MEMORANDUM

Date: February 10, 2022
To: Mr. Kelly Crowe, P.E., City Engineer
From: Thomas Francis-Siburg
CC: Mr. Marius Venter, Property Owner
Mr. Owen Trepanier, Trepanier & Associates, Inc.
Re: **601 Truman-919 Simonton**
Final Engineering DRC Comment Re. Truman Avenue Parking Lot

DRAWING TITLE:
 ARCHITECTURAL SITE PLAN & FLOOR PLAN, PHASE I

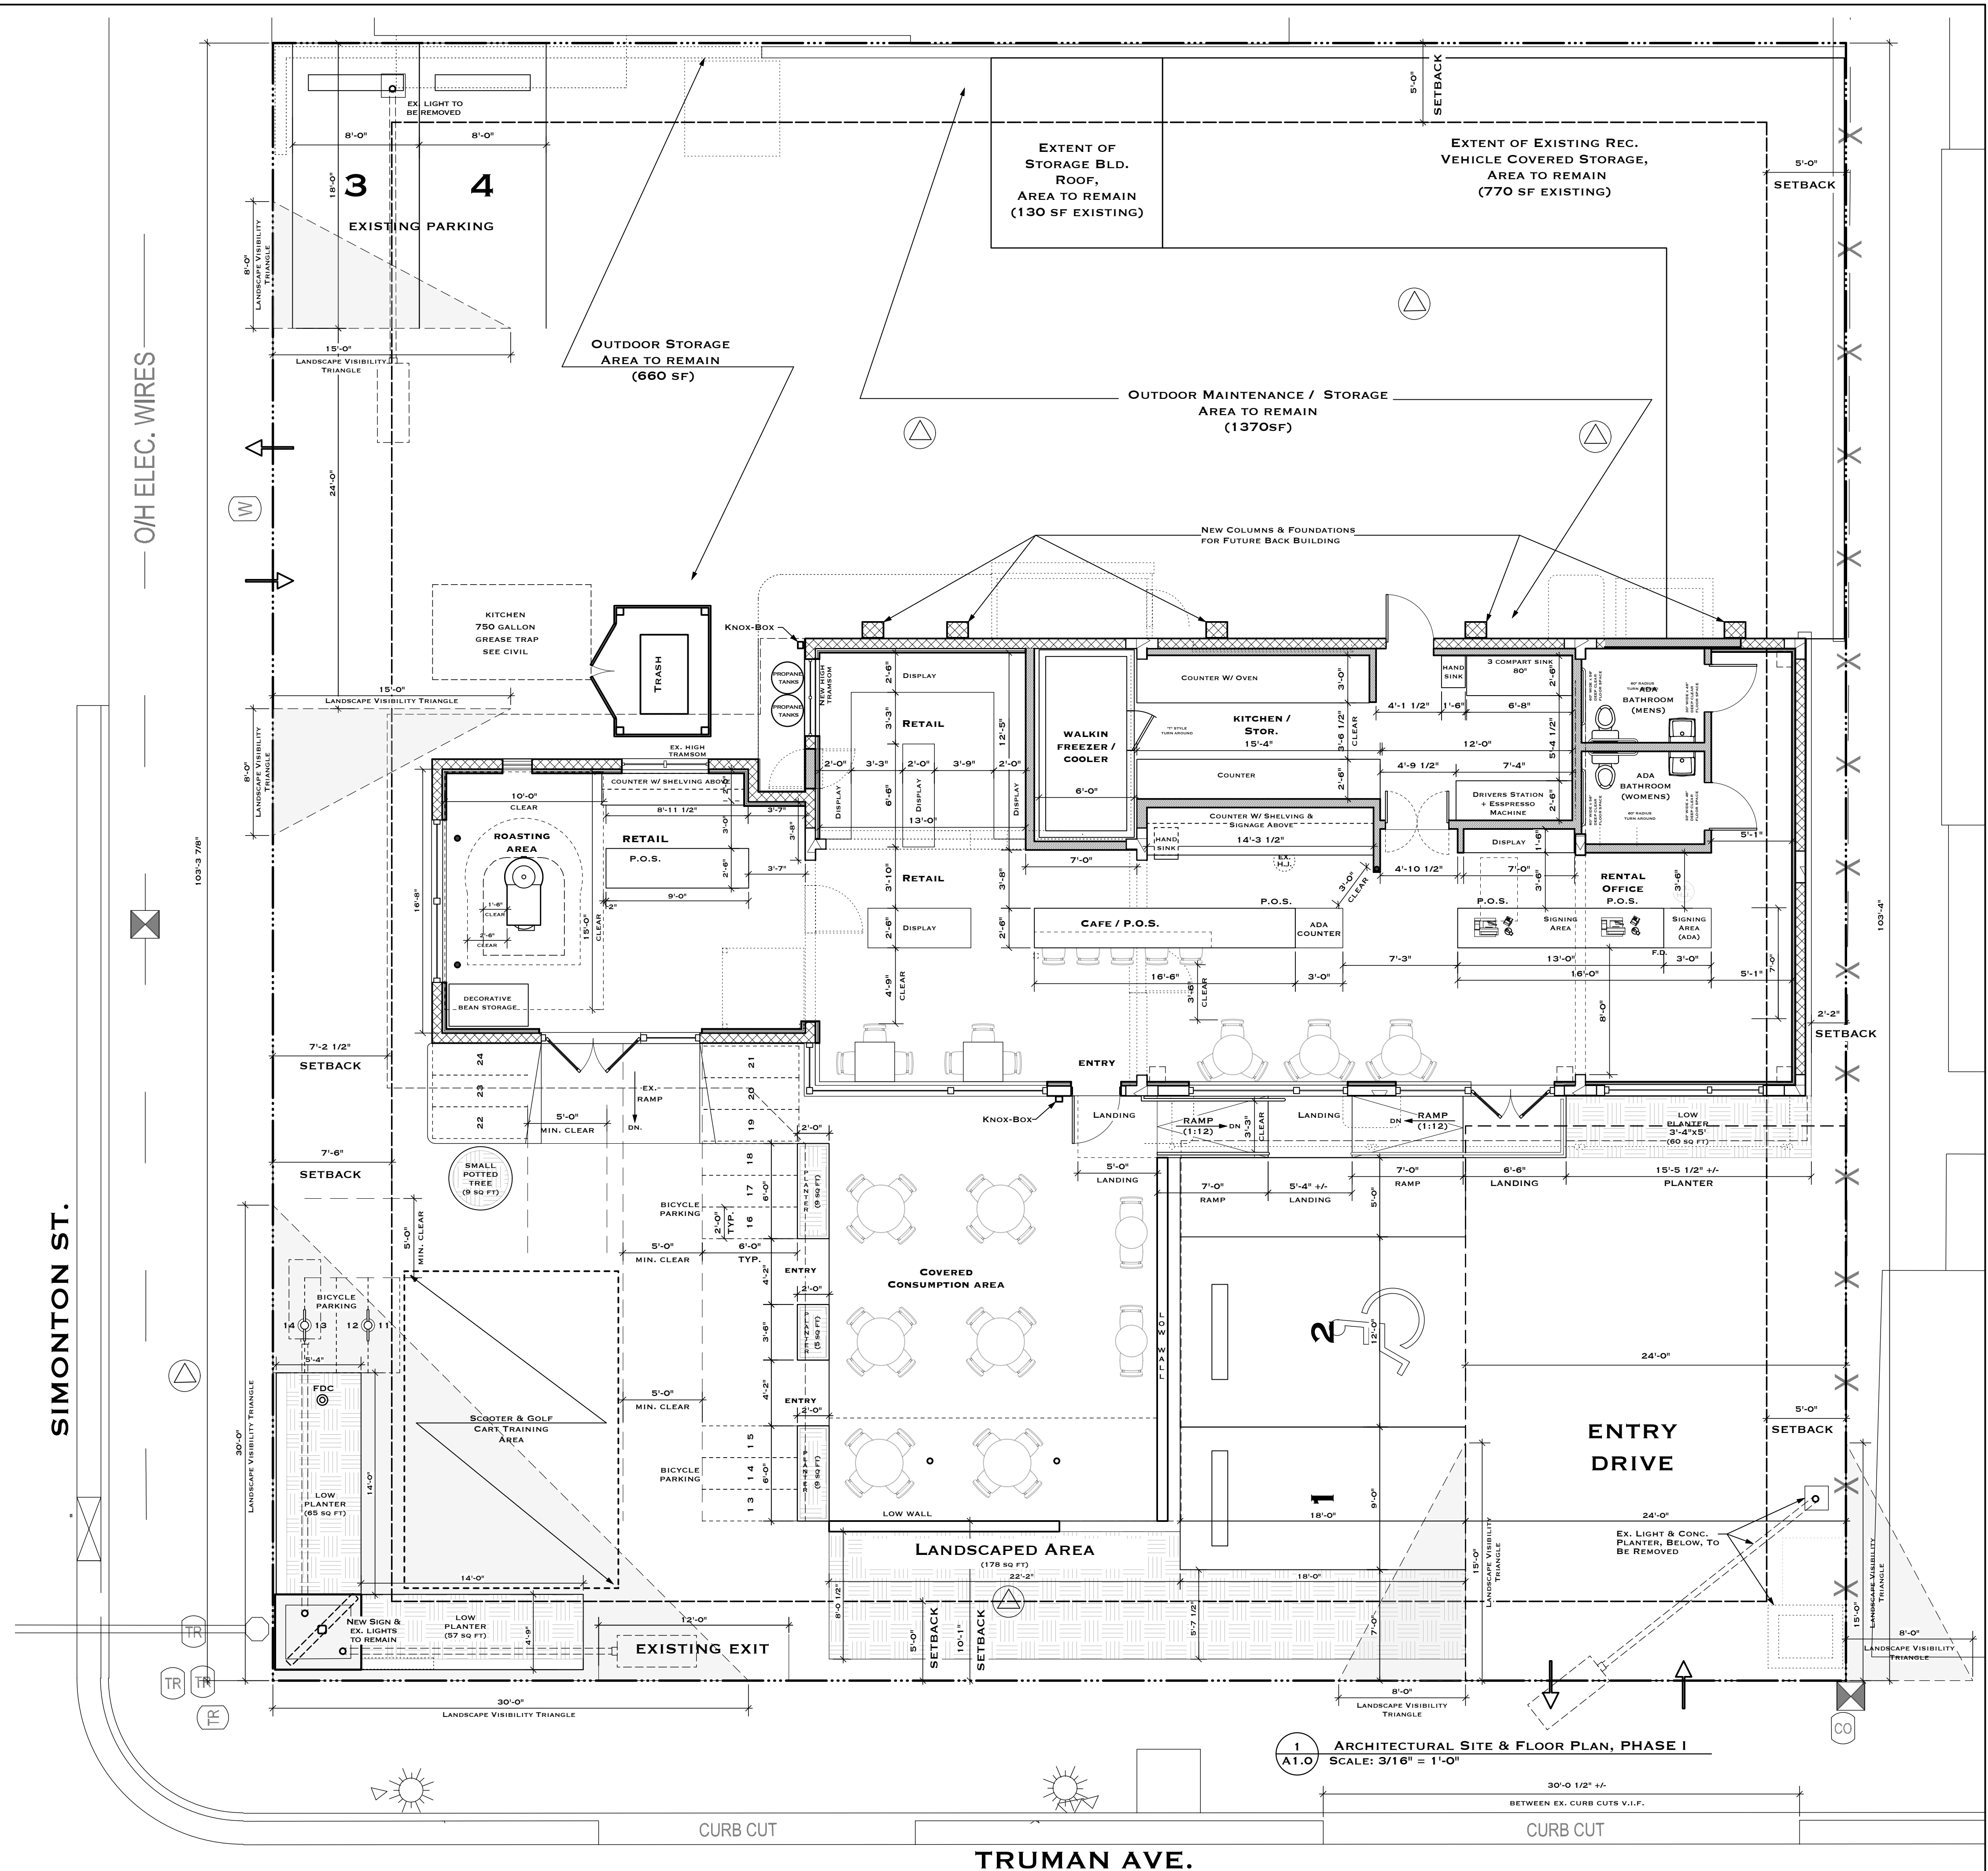
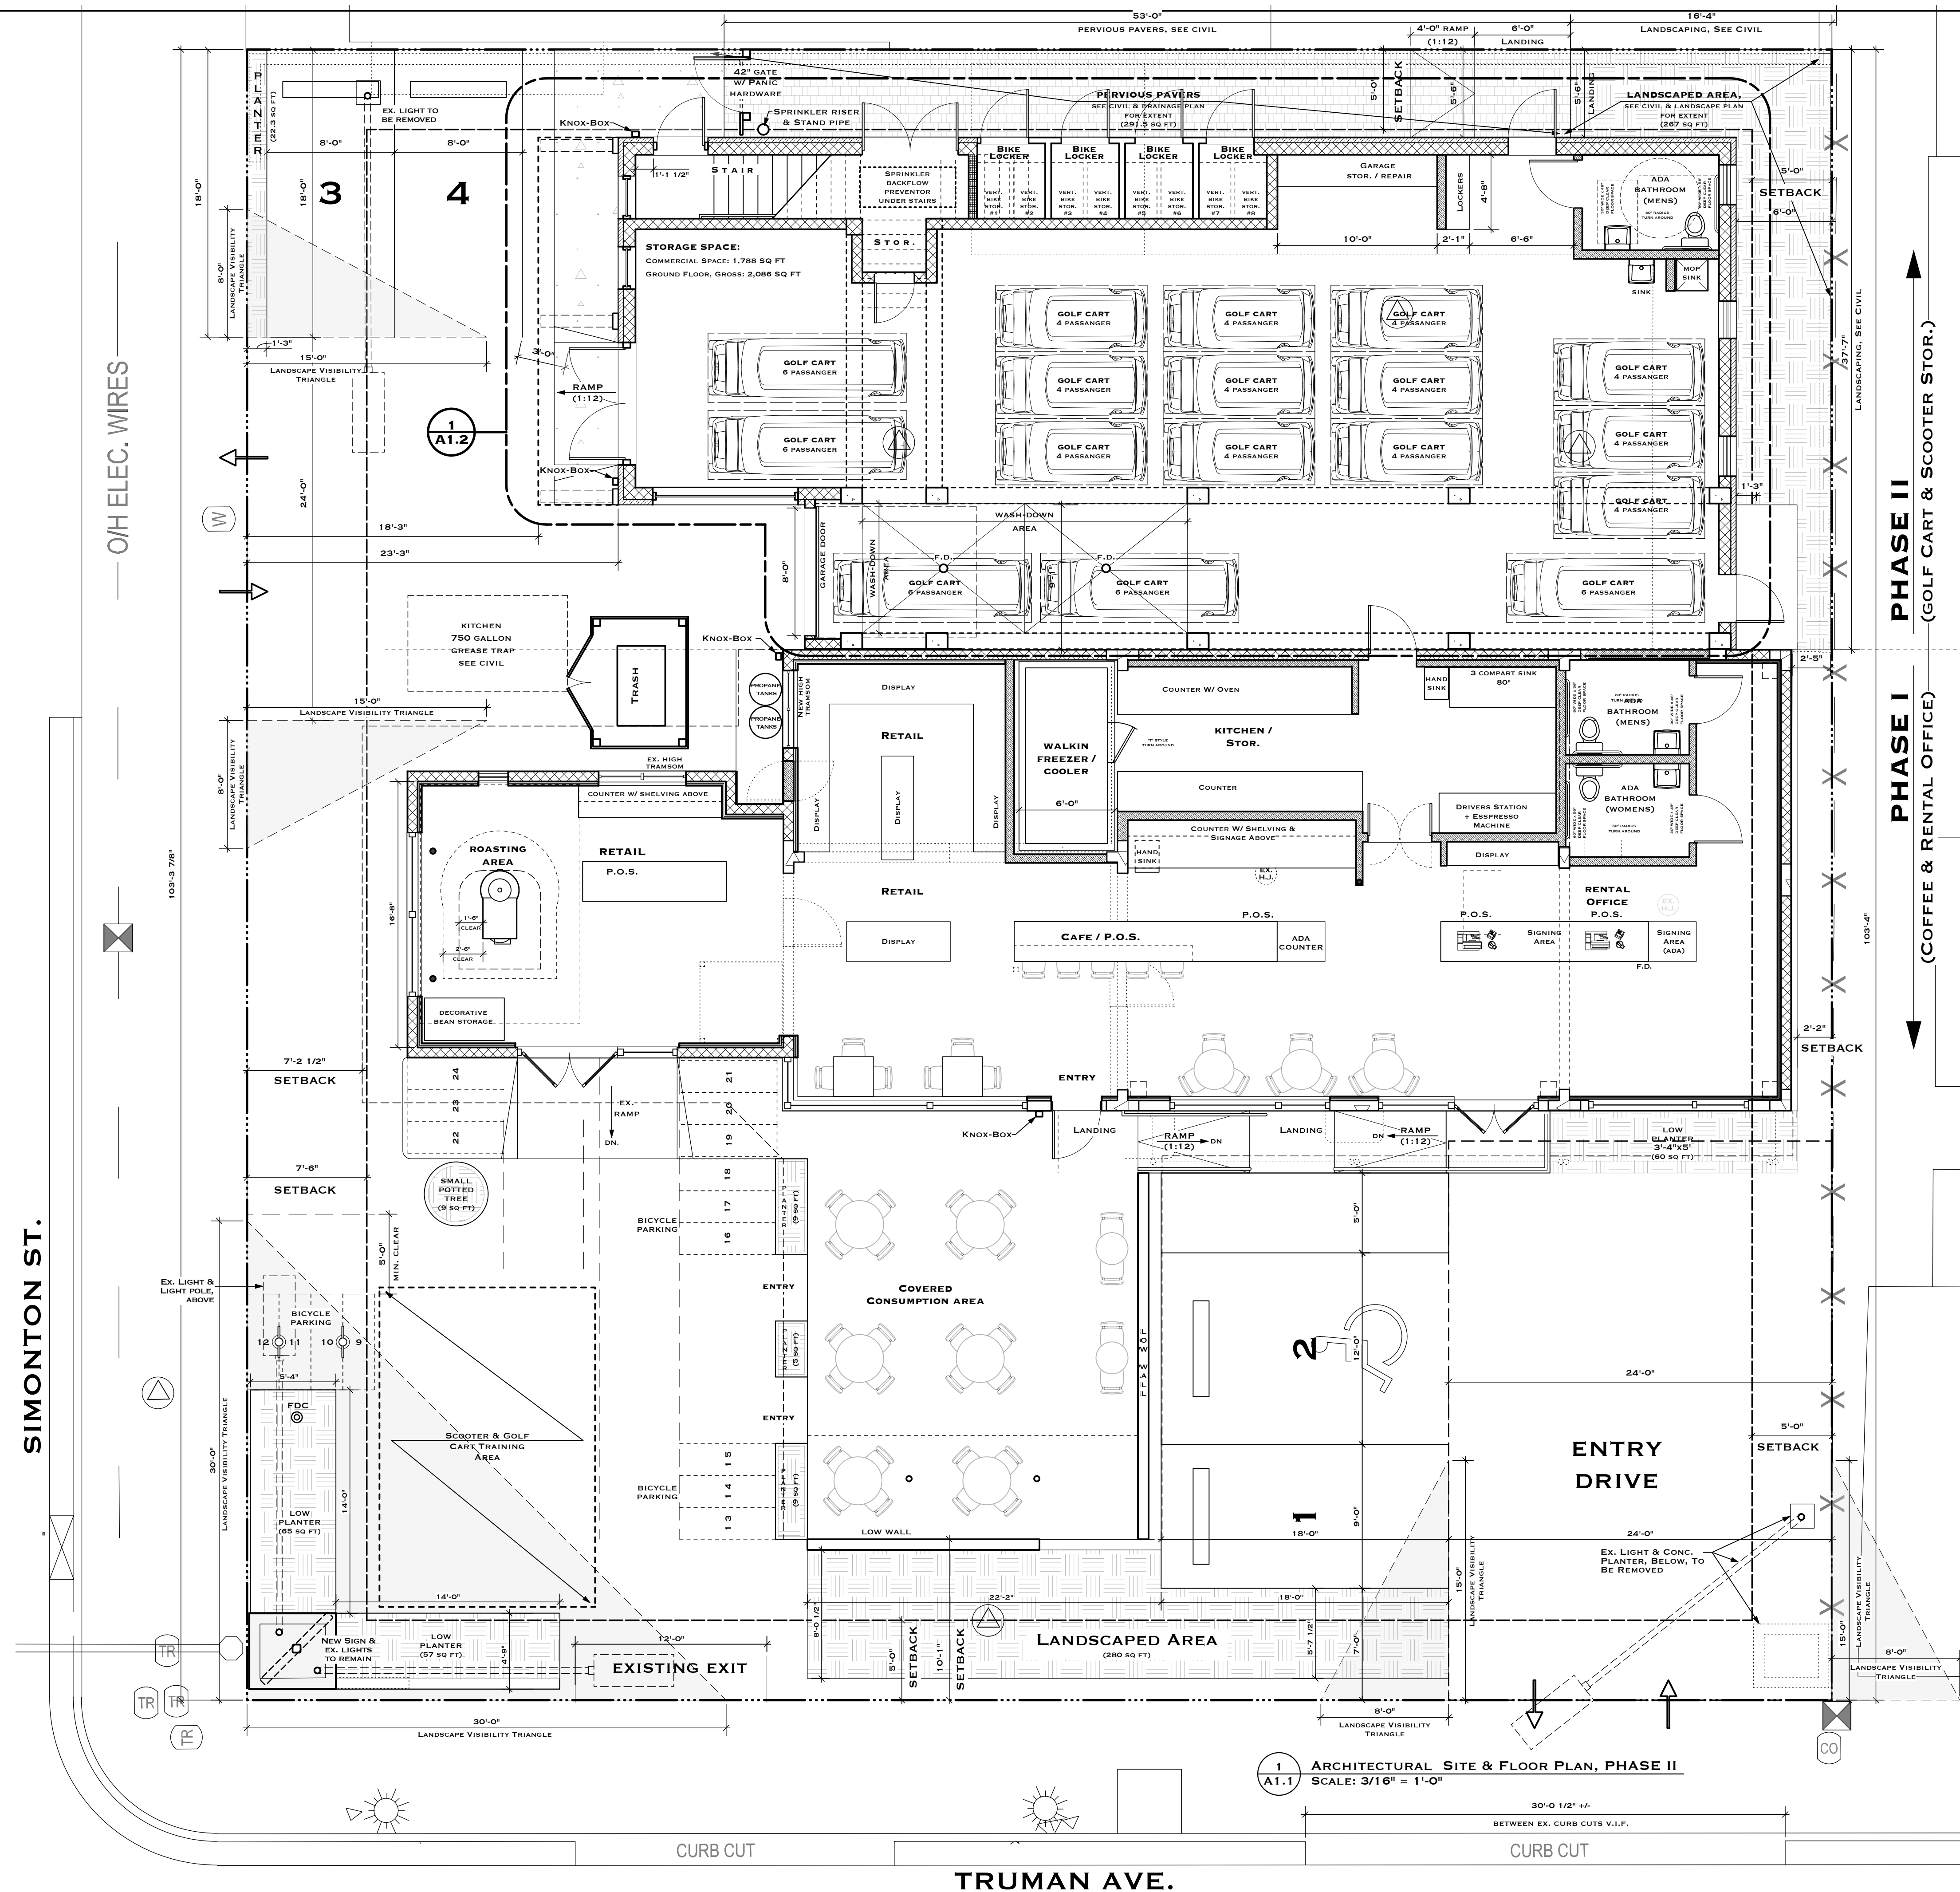
Comment – A parking space directly along the Truman Avenue sidewalk ROW creates a hazardous condition between cars pulling out of the parking lot and the ability to see oncoming pedestrians/ bicyclists in the sidewalk ROW. An unobstructed buffer space for visibility is needed. Requesting:

The attached plans depict our engineers' analysis and revisions to eliminate one parking space and provide a buffer as described above (Exhibit C). The inclusion of the buffer impacts the associated variance request by the loss of one parking space.
